TORRINGTON PLACE SUBDIVISION

APPLICATION NUMBER 10 DATE February 15, 2007

REQUEST Subdivision

DETAIL SITE PLAN

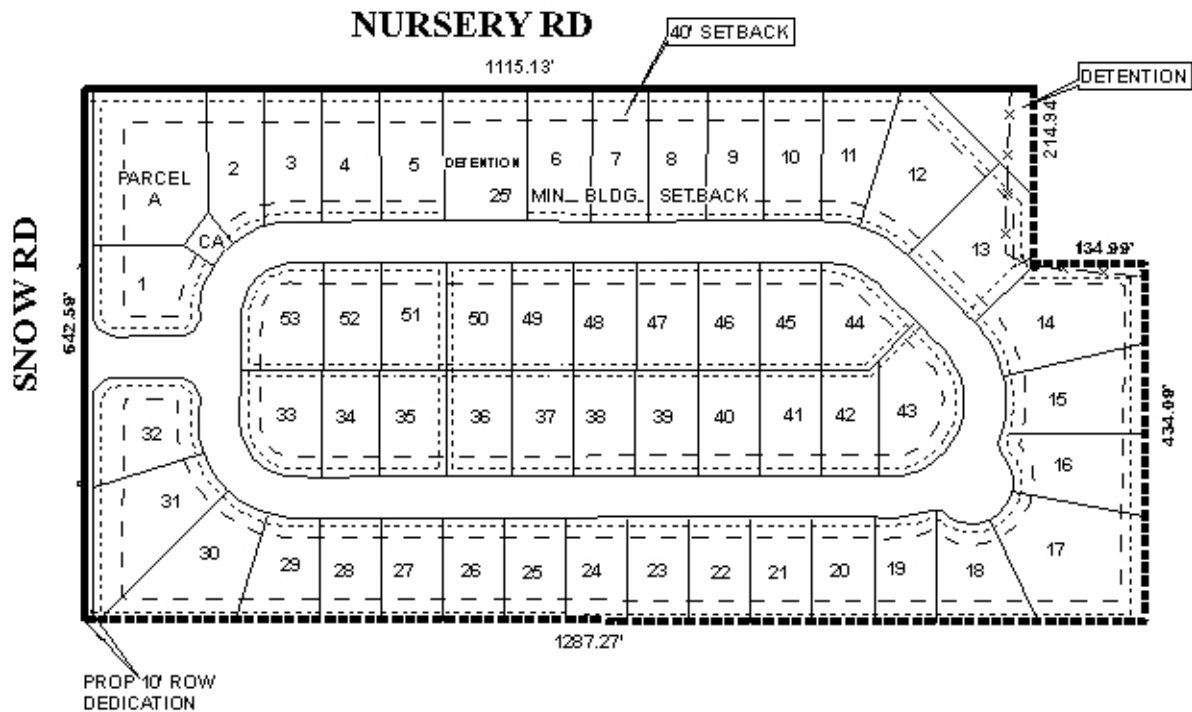
The site fronts onto Snow Road, a proposed major street, and Nursery Road, a minor street. Snow Road should have a right-of-way width of 100 feet instead of the existing 80 feet, and the preliminary plat depicts dedication of an additional 10-feet to Mobile County. Nursery Road has an adequate right-of-way, however, the preliminary plat indicates that the right-of-way is 80 feet, while GIS data indicates the right-of-way may be 60 feet in width: the width should be verified with County Engineering and the plat revised if necessary.

Access management is a concern for the site. The main portion of the subdivision will have access to Snow Road via internal streets, however, some lots will have double frontage. A note should be placed on the plat stating that all lots and the main detention area, with the exception of "parcel A," are denied direct access to Nursery Road and Snow Road North. The proposed "parcel A" should be renamed to "Lot 54," and should be limited to one curb-cut onto Snow Road and one curb-cut onto Nursery Road. The size, design and location of all curb-cuts should be approved by the Mobile County Engineering Department. It should also be noted that the detention area located at the Northeast corner of the site will only have frontage onto Nursery Road.

Detention basins and commons areas are proposed for the subdivision. The detention basins should be labeled as common areas and all common areas should be identified. A note should also be placed on the final plat, if approved, stating that maintenance of the common areas is the responsibility of the subdivision's property owners.

Based on the preceding, the plat meets the minimum requirements of the Subdivision Regulations and is recommended for Tentative Approval, subject to the following conditions: 1) verification of the right-of-way width for Nursery Road, and correction of the plat if necessary;

2) the dedication of right-of-way sufficient to provide 50-feet from the centerline of Snow Road, as depicted on the preliminary plat; 3) the renaming of "parcel A" to "Lot 54;" 4) placement of a note on the final plat stating that all lots and the main detention area, with the exception of lot 54, are denied direct access to Nursery Road and Snow Road North, that lot 54 is limited to one curb-cut onto Snow Road North and one curb-cut onto Nursery Road, and that the size, design and location of all curb-cuts are to be approved by the Mobile County Engineering Department; 5) labeling all common areas, including the detention basins, and placement of a note on the final plat stating that maintenance of the common areas is the responsibility of the subdivision's property owners; 6) provision of a letter from licensed engineer certifying compliance with the City of Mobile's stormwater and flood control ordinances to the Planning Section of Urban Development prior to the signing of the plat; 7) revision of the plat to label each lot in square feet, or provision of a table on the plat depicting the same information; and 8) placement of a note on the final plat stating that a buffer, in compliance with Section V.A.7. shall be provided where the commercial properties adjoin residential property.
